Re: Implementation of the Alternative Energy Portfolio Standards Act of 2004 Standards for the Participation of Demand Side Management Resources – Technical Reference Manual Update <u>Docket No. M-20051865</u> <u>M-00051805</u>

Docket No. M-00051865

COMMENTS OF DUQUESNE LIGHT COMPANY

Source: CFL Metering Study Final Report, KEMA, February 25, 2005

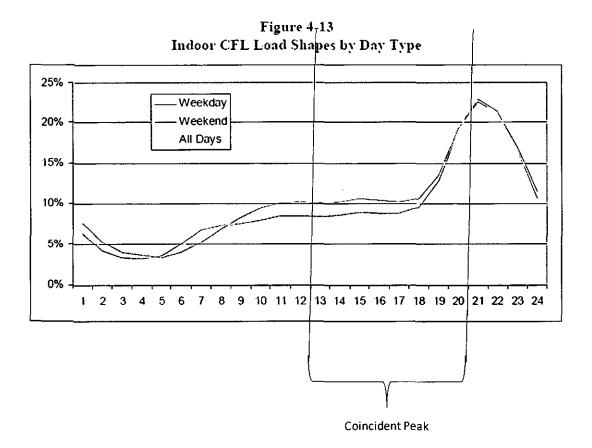
Coincidence factor ("CF") is the ratio of the "installed unit's connected load to its demand at time of system peak." Draft TRM at 15. Duquesne believes that the 5% CF adopted in Draft TRM Table 4-3 (on page 31 of the Draft TRM) is too low. As can be seen in the chart provided below, residential CFLs are used throughout the system coincident peak period as defined in TRM Table 1-1. The 3 average hours of use per day for residential CFLs also set forth in Table 4-3 are likely to occur between noon to 8 p.m., which coincides with the period of system peak. Accordingly, Duquesne finds the 5% extraordinarily low in view of this demonstrated use pattern. A more appropriate treatment would be to consider the 3 hours to be within the 8 hours and afford the measure to be 37.5% (3/8). Please see Table 1-1 from the Draft TRM and Figure 4-13 from the KEMA CFL Metering Study Final Report below for reference.

Based on this reference, residential CFLs operate across all 8 hours of the system coincident peak demand period. Accordingly, the stated daily 3 operating hours should be treated as occurring during the peak period 3 out of 8 hours or 37.5%.
